**Waterloo Metro Quarter Southern Precinct (SSD 10437):
Condition B11 Materials and Finishes**

Appendix A – Building 3 Student Housing Tower DRP Presentation

Appendix B – Sydney Metro DRP Advice and Actions Record

WATERLOO METRO QUARTER BUILDING 3 STUDENT HOUSING TOWER

BUILDING 3 GLAZING AND SUNSHADING
FINAL DEVELOPED DESIGN

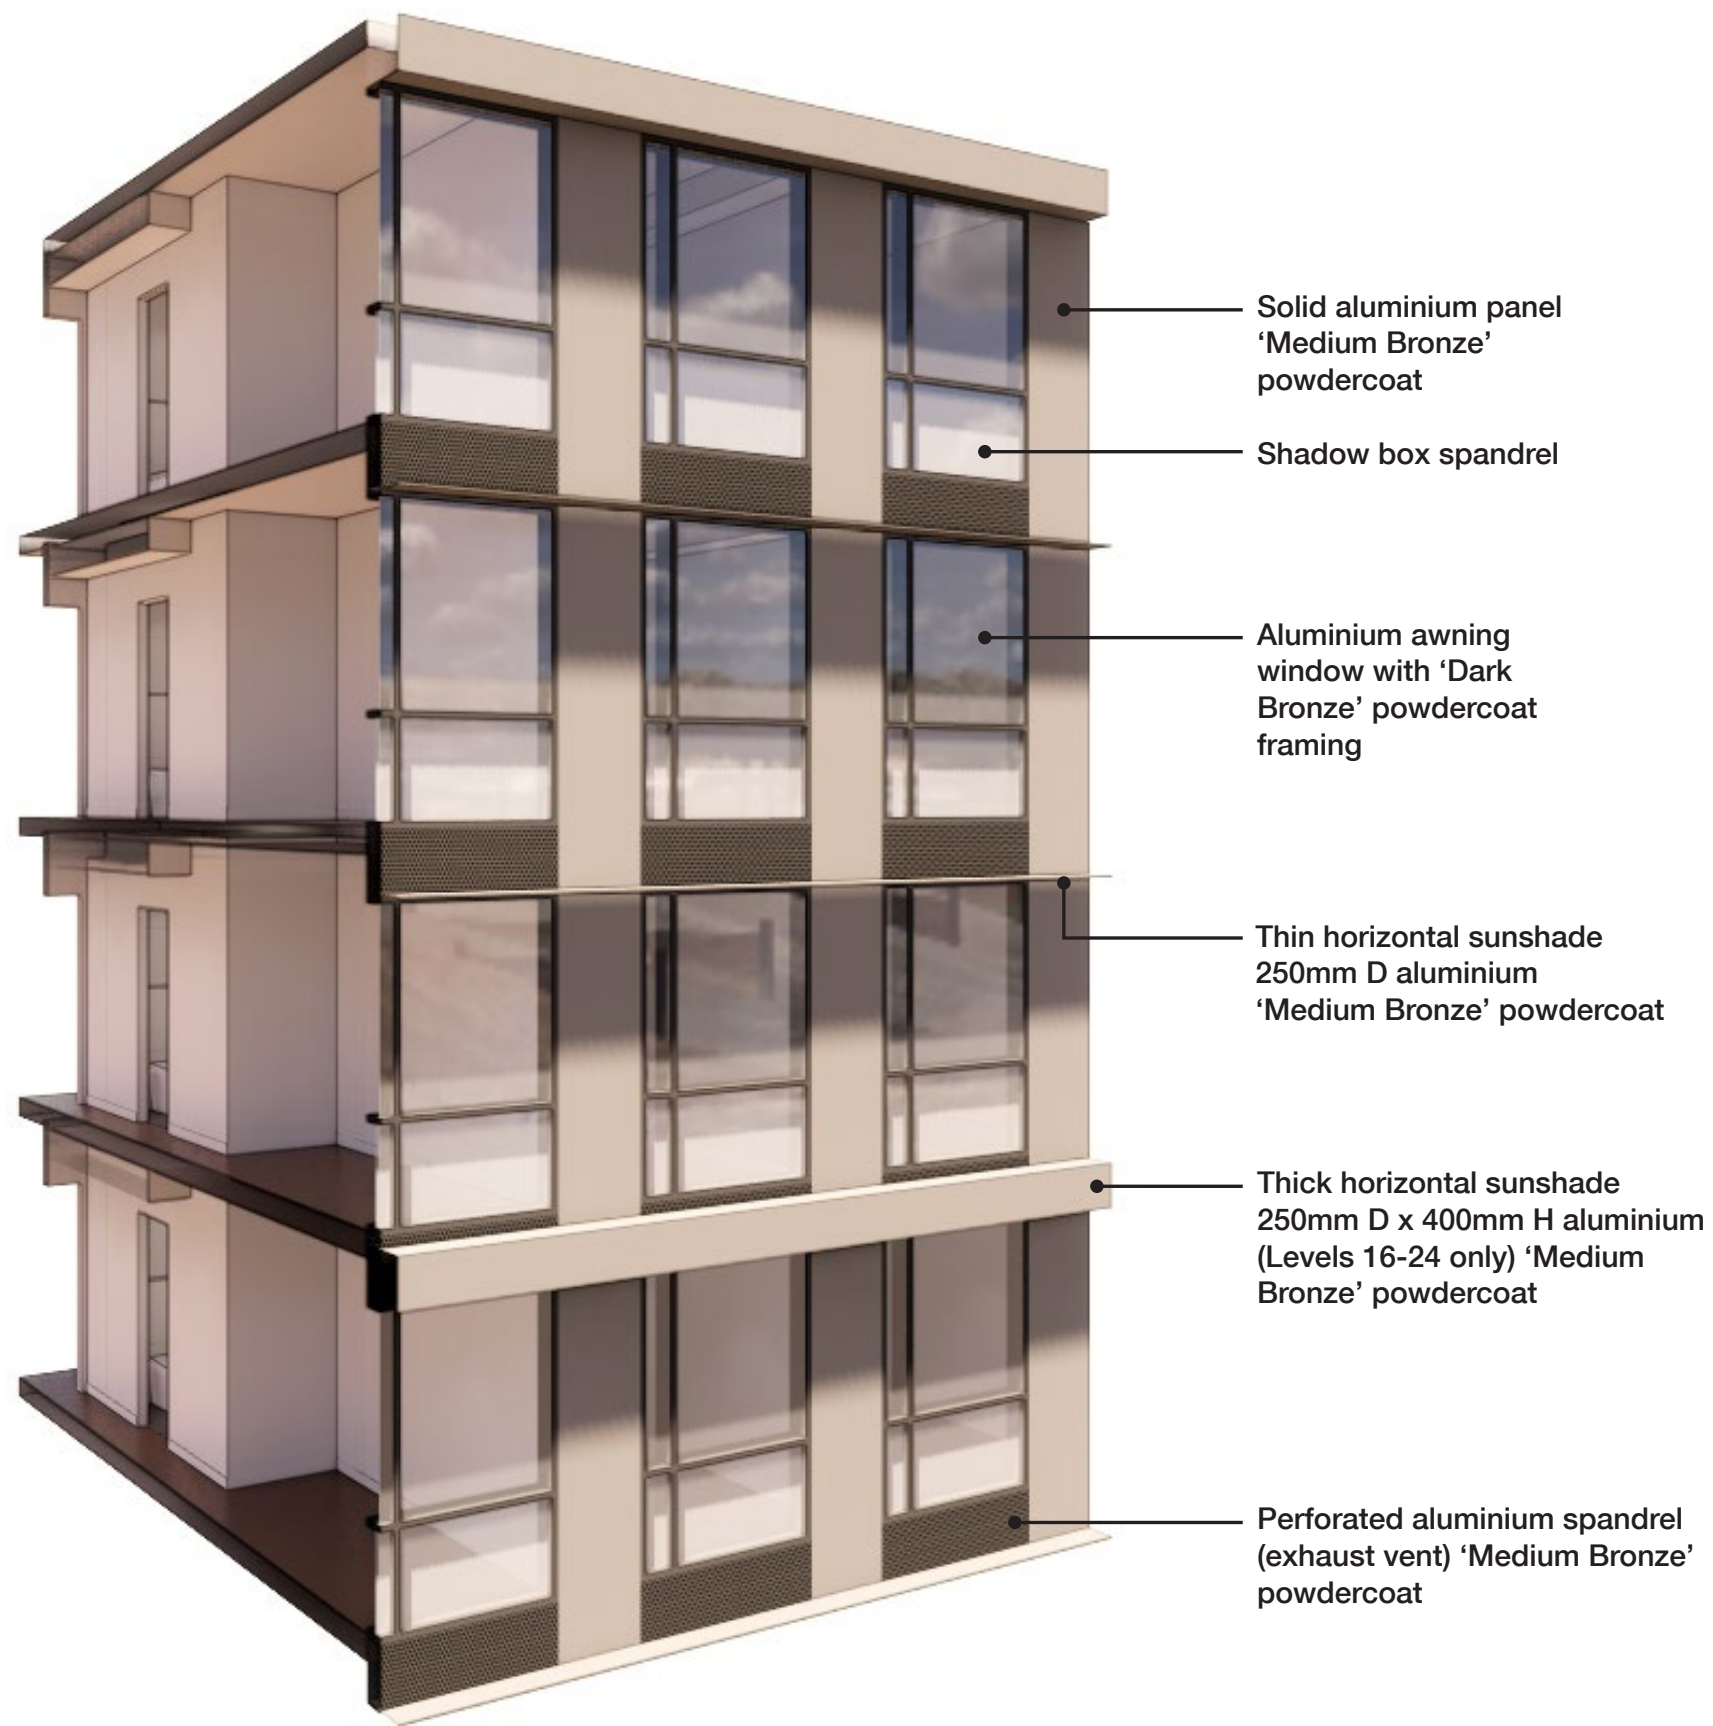
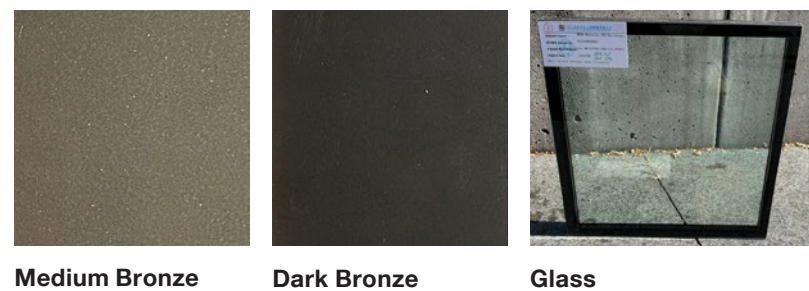
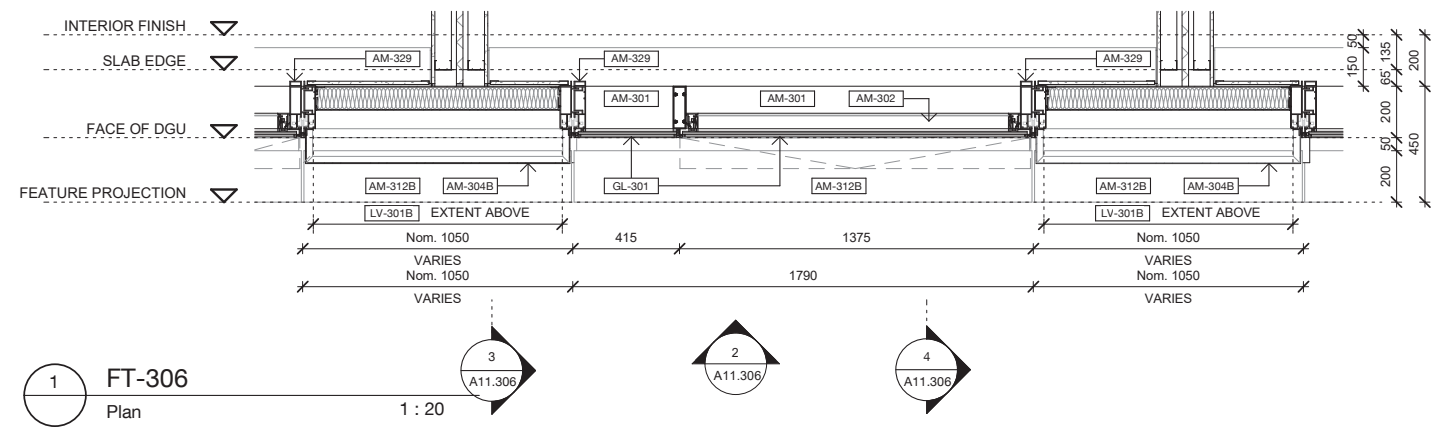
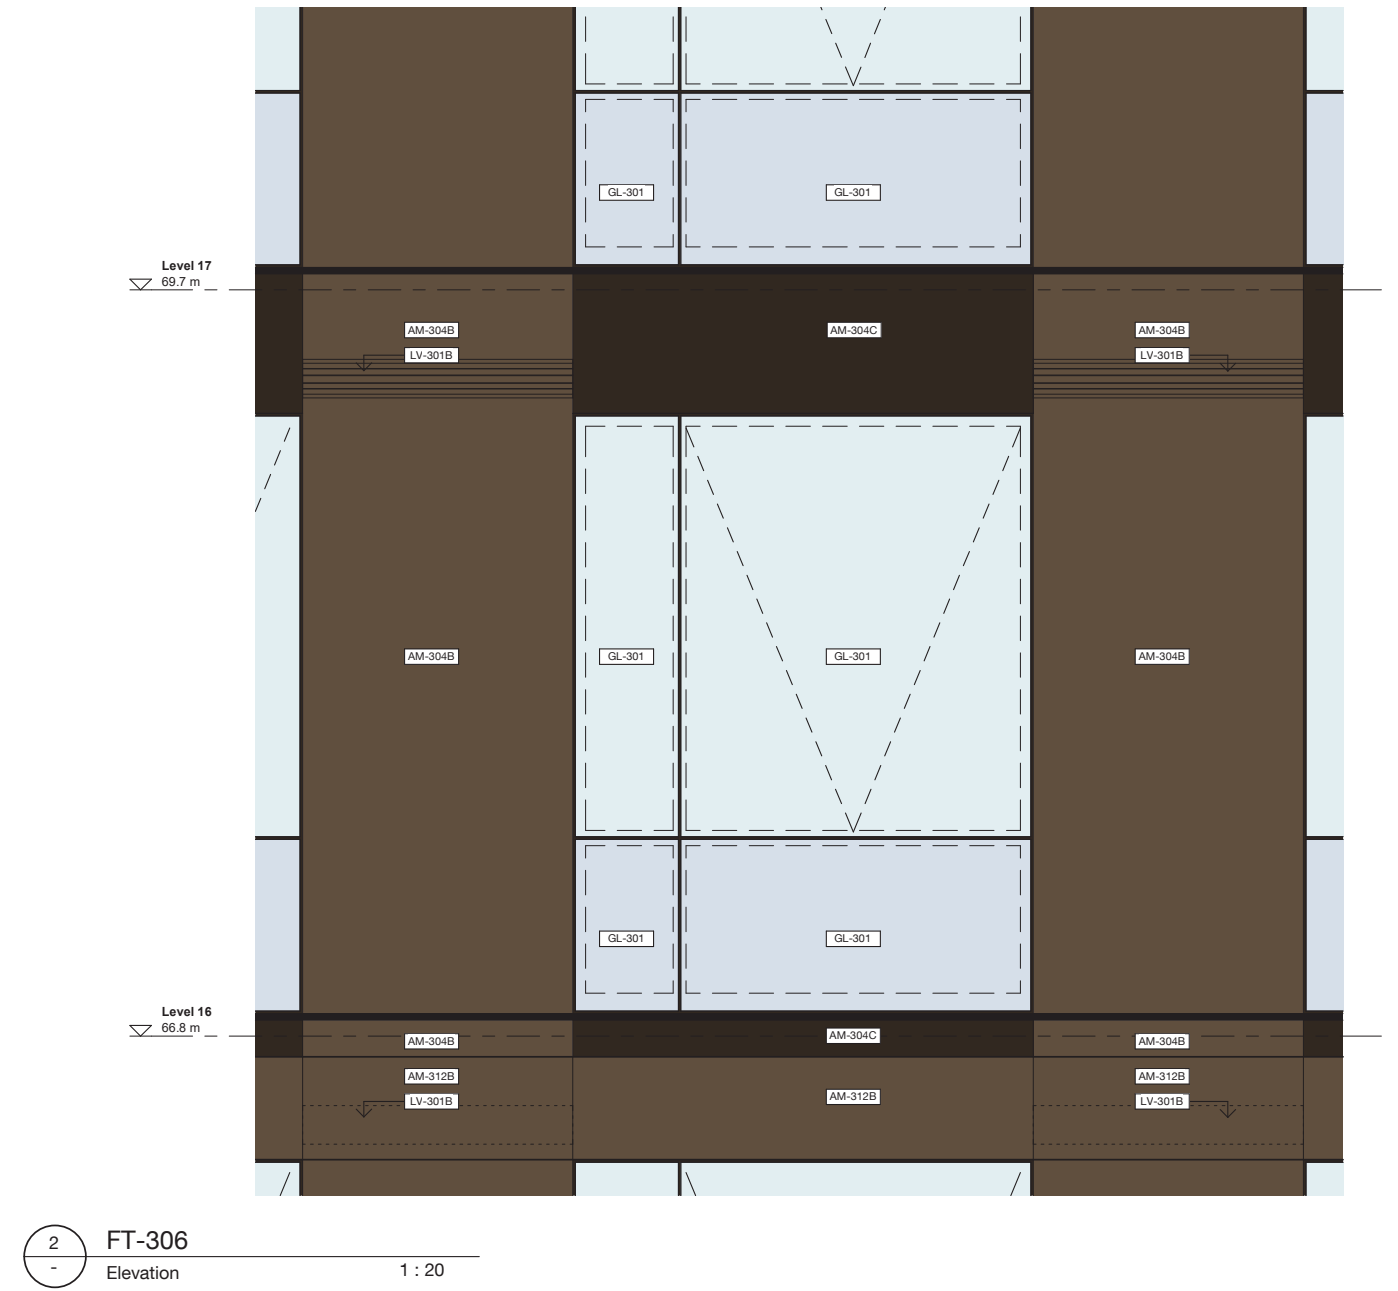
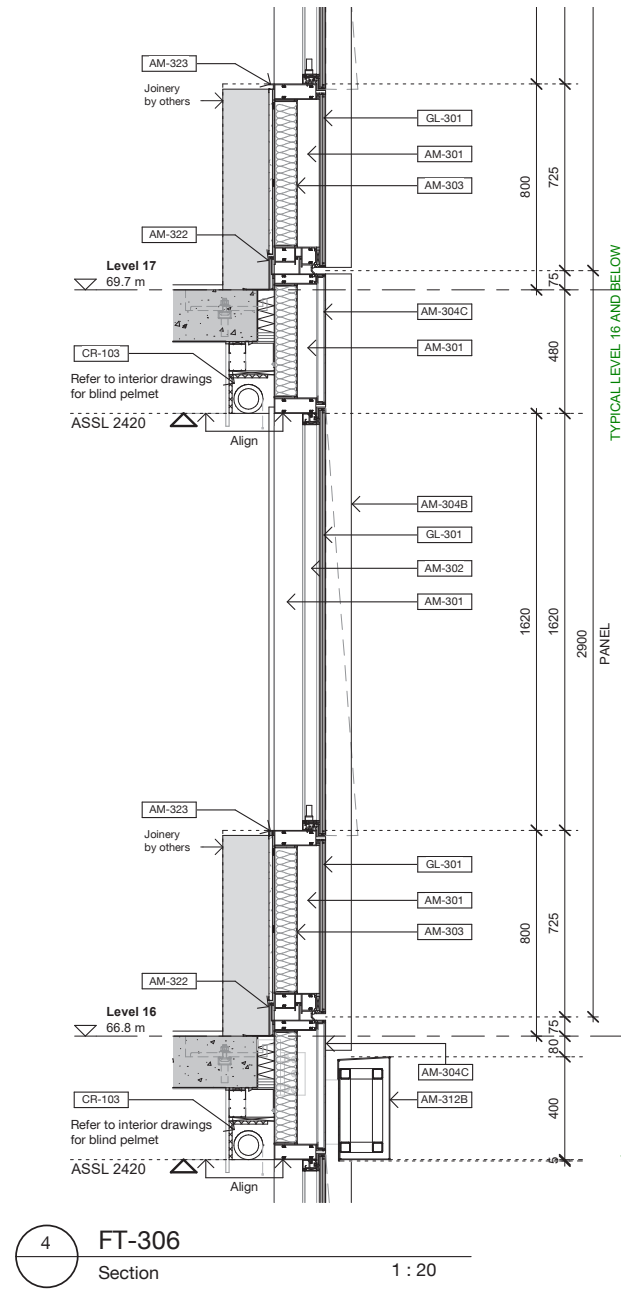
02.01	Waterloo Metro Quarter – Building 3 WDT provided an overview of the finishes proposed at SSDA and current selected façade treatment and finishes, noting that SSDA conditions stipulate that applicant must seek the advice of the DRP, prior to approval from the planning secretary. The Panel sought clarifications relating to: <ul style="list-style-type: none">• Sun penetration modelling and wind/acoustic testing on perforated sunshade• Measures to avoid staining, angled sunshade positioning and how it looks from inside the development• Confirmation that sunshade depth is consistent with SSDA• Colour differences, which may appear less pronounced on screen Comments: Panel supports the proposed materials and details and recommends: <ul style="list-style-type: none">• Technical reports to confirm the perforated sunshade meets solar protection requirements modelled, and no wind/whistling noise will be present• The design team to review colour selection once visual mock-ups are received to ensure appropriate colour contrast	WDT	Open

John Holland Building are currently undergoing the production of a Wind Generated Noise study for the façade(s) with assistance from a specialist consultant to provide a benchmark for the contractor testing, for the production of the external feature and sunshade fins.

Once prepared, the Wind Generated Noise Study will provide a base line acoustic level which the façade install contractor (Micos) will adhere to while manufacturing the fin/blades & acoustic testing regime.
